Draft Safety Evaluation Report

For the proposed reclamation plan
for the Sequoyah Fuels Corporation
Site in Gore, Oklahoma; Materials
License No. SUB-1010

Docket No. 40-8027
Sequoyah Fuels Corporation

U.S. Nuclear Regulatory Commission

Figure 1-2 The Disposal Cell Footprint and the Proposed ICB at the SFC Facility

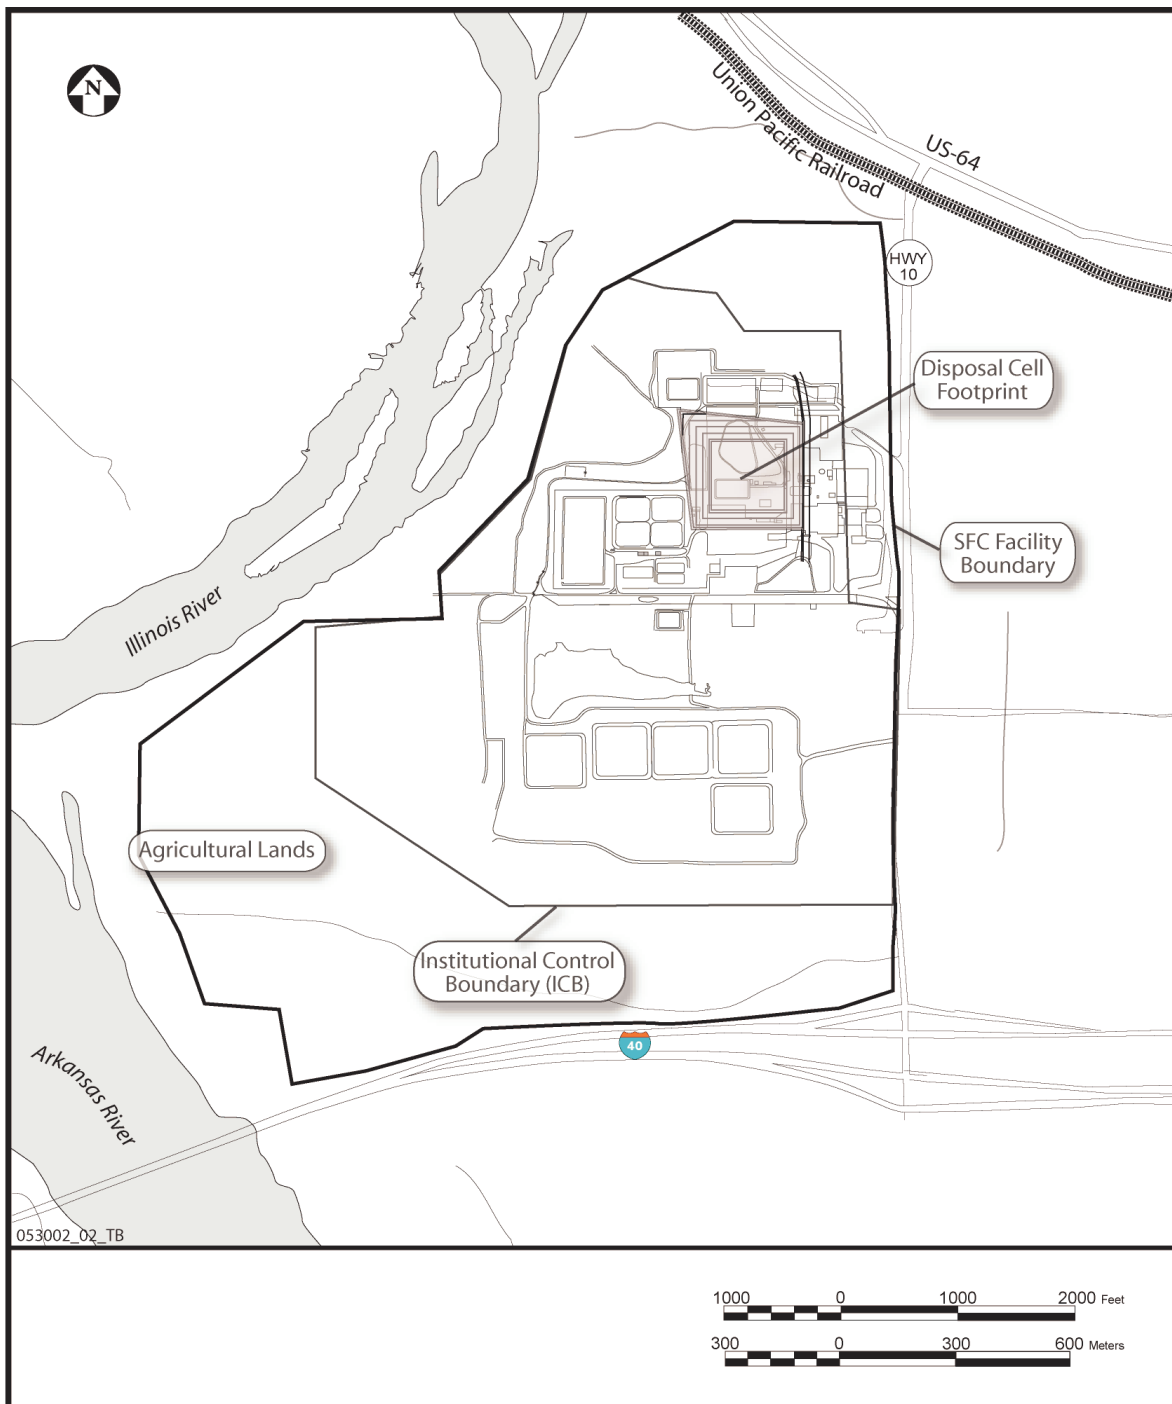
SFC proposes to build a disposal cell in the Process Area (see Figure 1-2). The cell will be a four-sided, domed structure, with a soil cover. The contaminated material will be placed in the cell in four layers, with the higher activity material nearer the bottom and less radioactive material near the top. Depending on the volume of material excavated during soil cleanup, the cell may hold from 5 million to 12 million cubic feet of waste. The waste will be underlain by a clay layer with a synthetic liner above providing additional seepage control. The contaminated material will be covered by a clay layer with a synthetic liner above the clay. Eight feet of earthen material will be placed above the synthetic cover material. The cover will be vegetated. The top will slope to the southeast at one percent. The side slopes will incorporate a rock mulch layer for erosion protection and have a 20 percent slope. The maximum height of the completed cell will be 30 to 50 feet above the surrounding ground elevation, depending on the volume of waste emplaced.

Figure 5-1 - Liner Cover Material Grain Size Curve

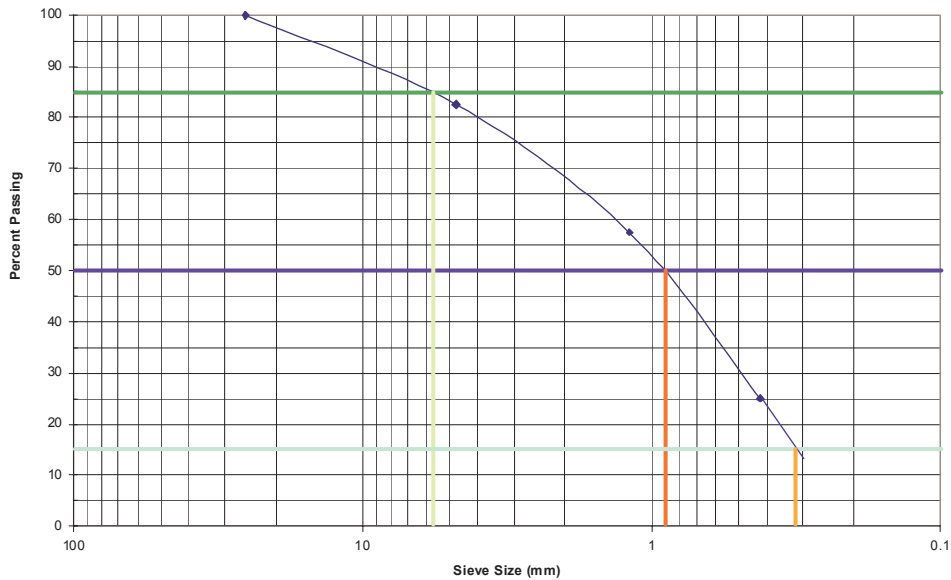
To determine the adequacy of the liner cover material filtering capacity, NRC computed a grain size distribution curve using the averages for the No. 4, 16, and 40 sieves (Figure 5-1). Linear extrapolation was used to continue the curve to the lower percent passing values. Quantiles of interest for the liner cover material are D_{50} and D_{15} , which equal 0.9 mm and 0.32 mm, respectively. Because no grain size data were provided for the fine-grained soil, conservative values for the D_{85} (0.074 mm) and D_{50} (0.01 mm), were assumed. Quantiles for the liner cover and the overlying fine-grained soil were compared using the USACE filter equations:

Solutions to equations 1 and 2 are 32 and 21, respectively. This indicates that the liner cover is not designed to prevent piping; however, it will provide sufficient drainage according to equation 2. The fact that the liner cover material does not meet the piping criteria may indicate that this layer is susceptible to clogging by fines from the overlying soil as they migrate through the liner cover material. **The NRC staff, therefore, considers this issue open. A similar issue was raised in the Section 2.3.2 of this SER regarding the geotechnical stability of the disposal cell.**
